ADDRESS: 1026 ARCH STREET
Proposal: Construct additions

Review Requested: Review In Concept

1026-28 ARCH STREET

RENDERINGS FOR HISTORICAL

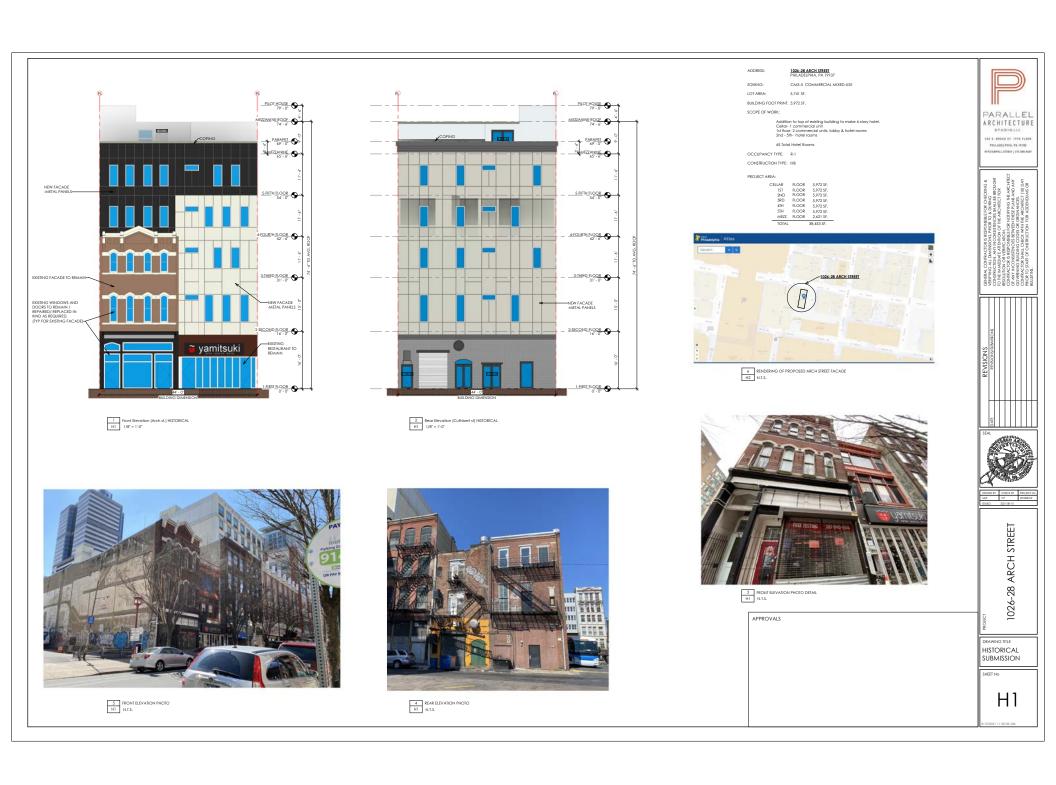
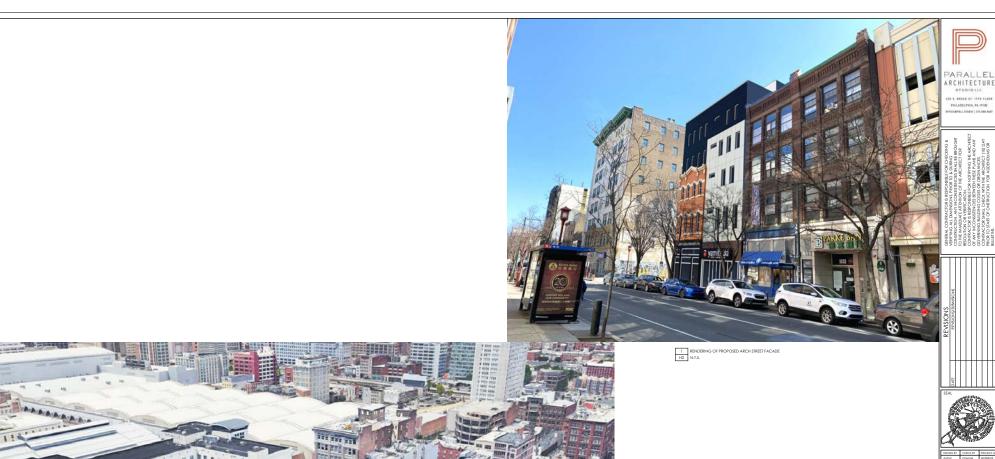
This in-concept application proposes the construction of a five-story building with mezzanine at 1026 and 1028 Arch Street. The property at 1026 Arch Street is designated. The property at 1028 Arch Street is not designated. Although not clear from the application materials, it appears that all but the front façade of the designated building at 1026 Arch Street would be demolished and the new five-story building constructed behind the historic façade. A rendering of the front from the northwest appears to show that the new building would emerge from directly behind the historic façade, with no setback. The rear elevation shows an entirely new façade, without a trace of the historic rear façade. A rendering from the southeast appears to show an entirely new building at the side and rear. Without a site plan, roof plan, demolition plan, section, or side elevation, it is impossible to determine how much of the old building would be retained and how much would be demolished. The application references a two-story addition on the historic building, but only calls out the retention of the front façade, indicating that the remainder of the historic building may be demolished and replaced with new construction.

- Section 7.2.e: For applications proposing work to designated exteriors, a legible, dimensioned, accurately-scaled plot or site plan.
 - No plot or site plan is provided.
- Section 7.2.g: Legible, dimensioned, accurately-scaled drawings of the proposed alterations. If demolition is proposed, the area(s) of demolition must be clearly delineated on the drawings. Detailed drawings are not required, but the drawings must convey the concept.
 - No demolition plan is provided. The submission is incomplete.

STAFF RECOMMENDATION: Denial, pursuant to Section 14-1005(6)(d) of the historic preservation ordinance, the demolition prohibition, and owing to incompleteness.
